Access Compliance Report

Public Rights-of-Way

Intersection ID: 30236	Main Street: HELMS_RD	Cross Street: LEECREST_DR	Location: E
ADA ID: A899488ACE5F	Ramp Type: BlendTrans1	Initial Pass/Fail: Fail	Overall Compliance: No
		Severity Score: 25

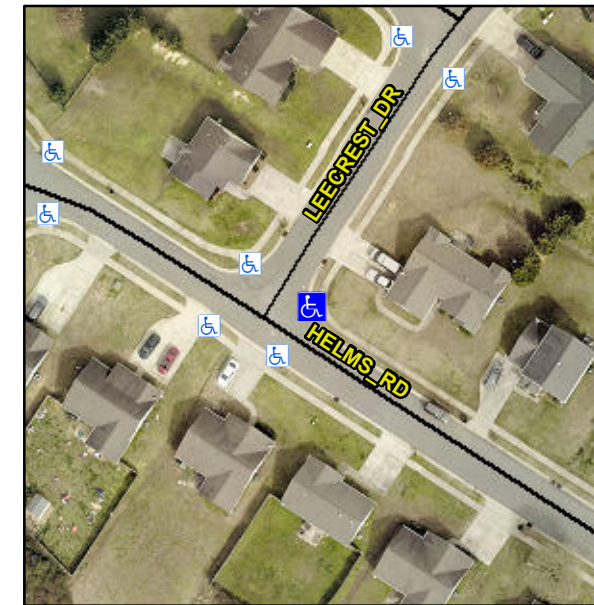
Not Found, R304.5.3

Compliance	Description	Data	Compliance	Description	Data
N/A	Ramp Length (in)	48.0	Yes	BlendTrans Slope (%)	2.5
Yes	Ramp Width (in)	48.0	No	BlendTrans XSlope (%)	7.5
N/A	Flare Type LT	N/A	N/A	Flare Type RT	N/A
N/A	Flare Slope LT (%)	N/A	N/A	Flare Slope RT (%)	N/A
N/A	Flare Traversable LT?	N/A	N/A	Flare Traversable RT?	N/A
N/A	Landing Length (in)	N/A	N/A	DWS Provided?	N/A
N/A	Landing Width (in)	N/A	N/A	DWS Contrast?	N/A
N/A	Landing Slope (%)	N/A	N/A	DWS Length (in)	N/A
N/A	Landing X Slope (%)	N/A	N/A	DWS Full Width?	N/A
N/A	Landing Curb? (Y/N)	N/A	N/A	DWS Offset (in)	N/A
N/A	Shared Landing?	N/A			
N/A	Gutter Ponding?	N/A	N/A	Gutter Slope (%)	N/A
N/A	Gutter Lip Ht (in)	3.0	N/A	Gutter X Slope (%)	N/A
N/A	Painted X Walk1?	No	N/A	Painted X Walk2?	No
	X Walk 1 Direction	To NW		X Walk 2 Direction	To SW
	X Walk 1 Width (in)	N/A		X Walk 2 Width (in)	N/A
	X Walk 1 Slope (%)	4.6		X Walk 2 Slope (%)	1.6
	X Walk 1 X Slope (%)	2.8		X Walk 2 X Slope (%)	3.8

Remove & Replace Curb Ramp With Two New Directional Ramps or Equivalent.
